**Re: Request for Well Closure at former Colombo Bakery, 580 Julie Ann Way, Oakland,
CA 94621**

Re: Tier 1 and Tier 2 RBCA Evaluation for 580 Julie Ann Way, Oakland CA 94621

RESPONSE TO COMMENTS ON SECOR's DECEMBER 14, 1995 WORK PLAN FOR SITE INVESTIGATION AT 580 JULIE ANN WAY, OAKLAND, CALIFORNIA, FOR SAN FRANCISCO FRENCH BREAD COMPANY

**Re: Comment on SECOR 12/14/95 Work Plan for Site Investigation at
580 Julie Ann Way, Oakland CA 94621, SF French Bread Company**

FIGURE 1
SAN FRANCISCO FRENCH BREAD
580 JULIE ANN WAY
OAKLAND, CALIFORNIA
ROSE DIAGRAM
GROUNDWATER FLOW DIRECTION
AT YANDELL TRUCKING PROPERTY
JULY 1994 THROUGH NOVEMBER 1995

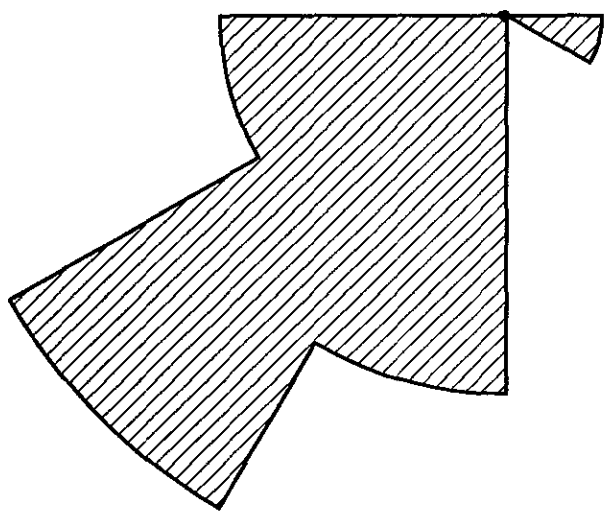
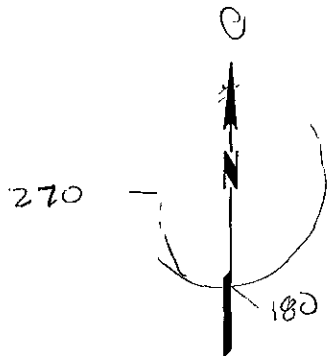
2. Although monitoring wells exist at the Yandell Trucking site at 563 Julie Ann Way, the groundwater gradient there has varied from southeasterly to westerly. The lone well proposed accounts for only a westerly groundwater gradient.

3. Because of the variation of gradient at the Yandell Trucking site, three wells is the minimum number of wells required to determine site specific gradient.

Response: *SECOR* obtained groundwater monitoring data for the Yandell Trucking property from CET Environmental Services, the environmental consultant for this property. *SECOR* reviewed groundwater elevation data from 14 monitoring events collected between July 1994 through November 1995. Groundwater flow direction from these monitoring events is displayed graphically on a rose diagram provided as Figure 1. These data indicate that the groundwater flow direction at this property has been consistently to the southwest with the exception of one anomalous result in January 1995.

Response: Data from the Yandell Trucking property indicate that there is little variation of groundwater flow direction at this property. Based on the proximity of the Yandell Trucking property in relation to the Site (less than 100 feet), it appears reasonable to conclude that groundwater beneath the Site has a similar groundwater flow direction.

FIGURE 2
SAN FRANCISCO FRENCH BREAD
580 JULIE ANN WAY
OAKLAND, CALIFORNIA
**SITE PLAN WITH PROPOSED
MONITORING WELL LOCATION**

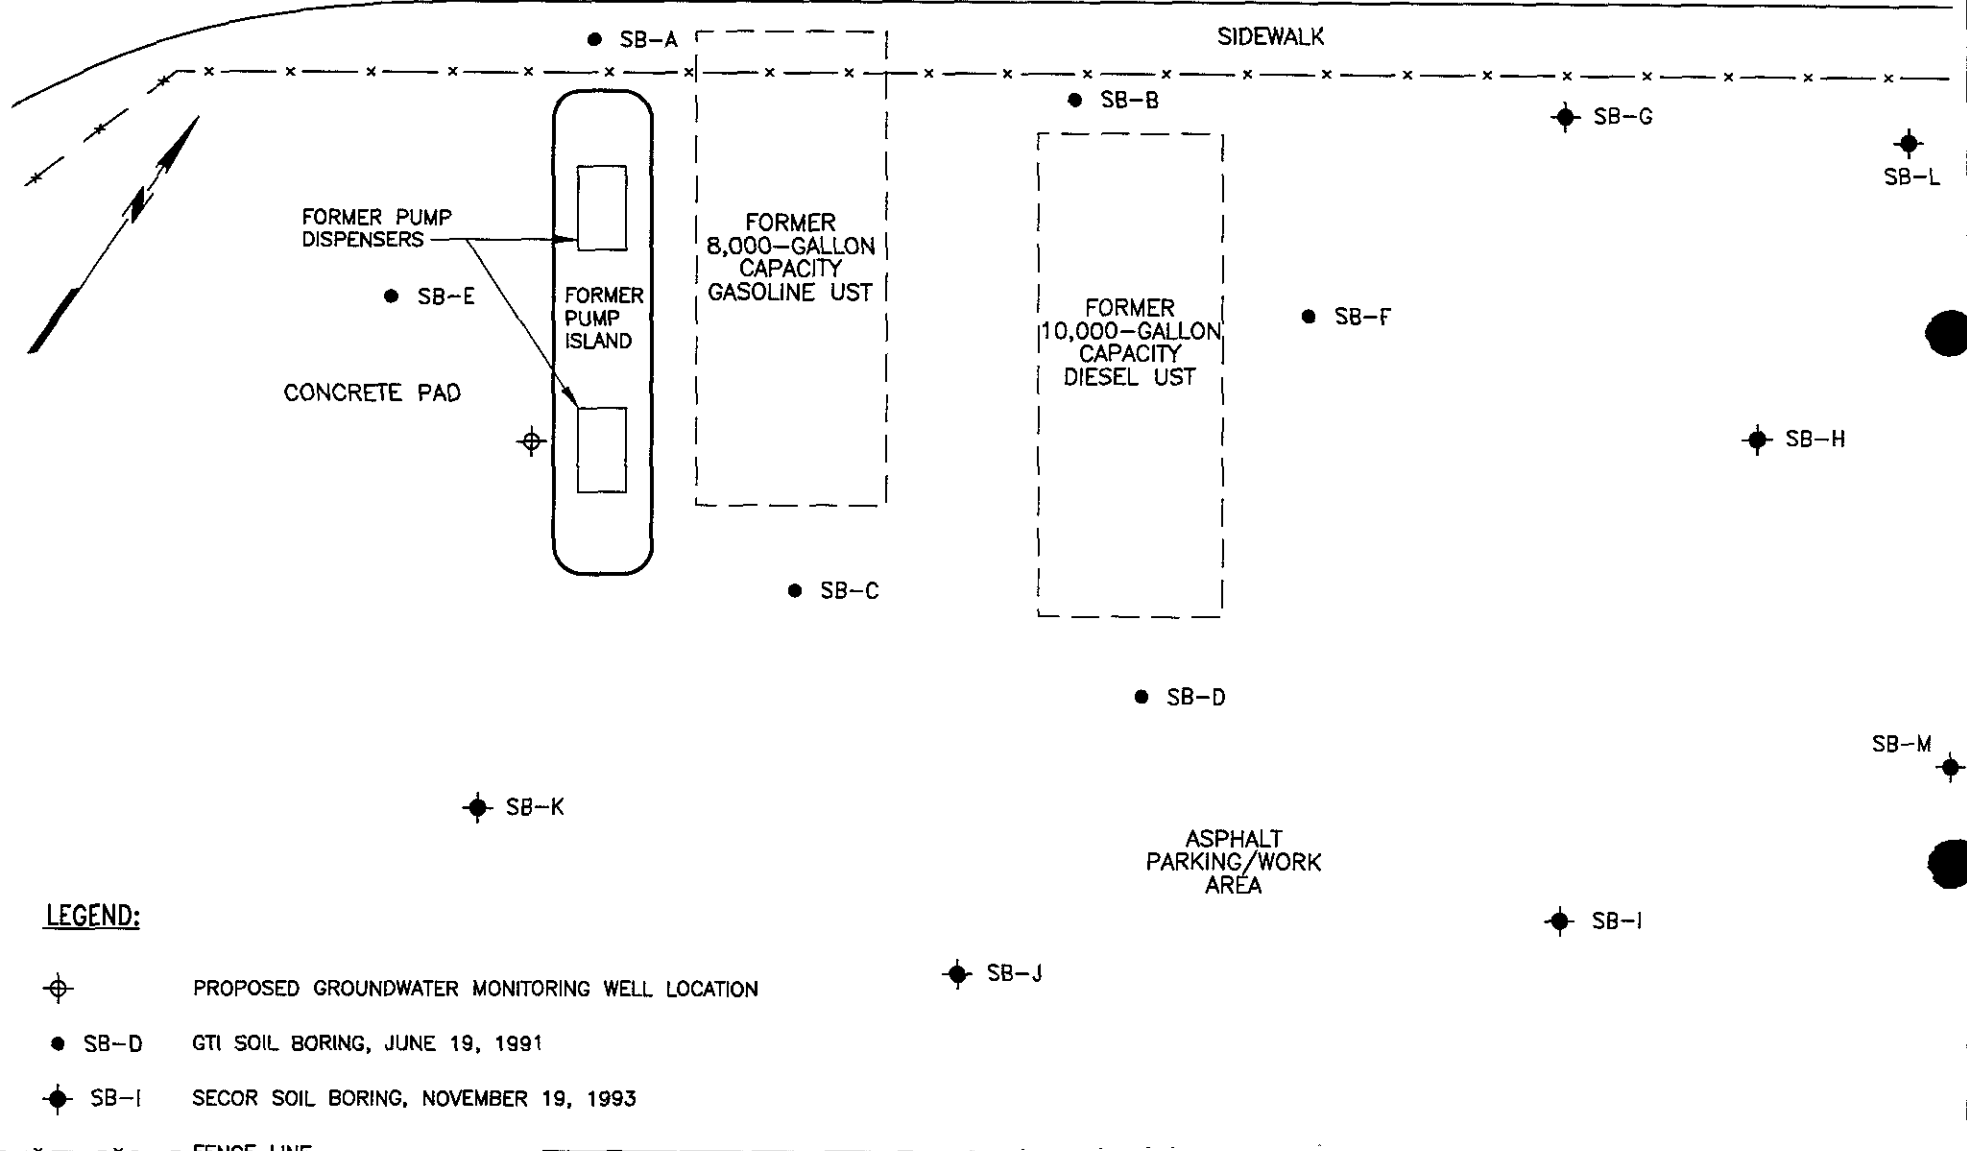
1. It is unclear whether the soil beneath sample DSW3' (the south dispenser) was ever overexcavated. Gasoline, diesel and BTEX was detected in this soil sample at elevated levels.

In your original request for a Work Plan dated November 7, 1995, it was stated that "at least one monitoring well in the verified downgradient direction relative to the excavation pit must be installed within 10 feet of the edge of the excavation." *SECOR* believes that the data collected from the Yandell Trucking property, located less than 100 feet north of the Site, provides a verified groundwater flow direction and accordingly, a single well will be adequate to determine whether groundwater impact from the USTs has occurred. *SECOR* and the SFFBC understand that additional groundwater characterization may be required based on the results of this initial groundwater investigation.

Based on our review of groundwater data from the Yandell Trucking property, *SECOR* proposes to adjust the proposed groundwater monitoring well location to a more southwesterly location relative to the former

USTs as shown on Figure 2. This adjusted location is also in the immediate vicinity of the former south dispenser (sample DSW3') and will address the ACDEH's concern regarding elevated petroleum hydrocarbon concentrations in this area. If you have any questions or comments please do not hesitate to contact us at (415) 882-1548.
